#### **MEMORANDUM**

TO: City of Milwaukee Plan Commission

FROM: John M. Wirth, counsel for Save MKE's Music Scene LLC

SUBJECT: The Live Nation/Frank Productions Proposed Concert Venue Building Has no

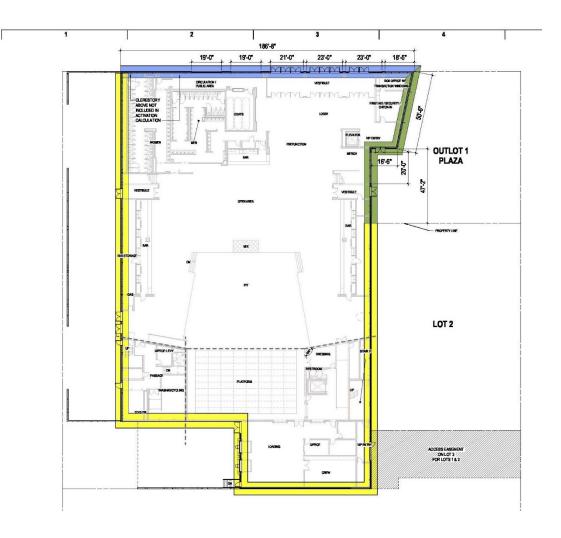
The developer should be required to fulfill its commitment to Turner Hall now. In just nine years, the developer has changed and diminished its plans for this property. You can bet it will again change its tune when (if ever) it proposes something for Lot 2. You can hear them now: "The economics do not allow for the construction of anything interesting on Lot 2 or to cover the 50 feet of blank wall south of Lot 2 in the southeast corner of the venue building."
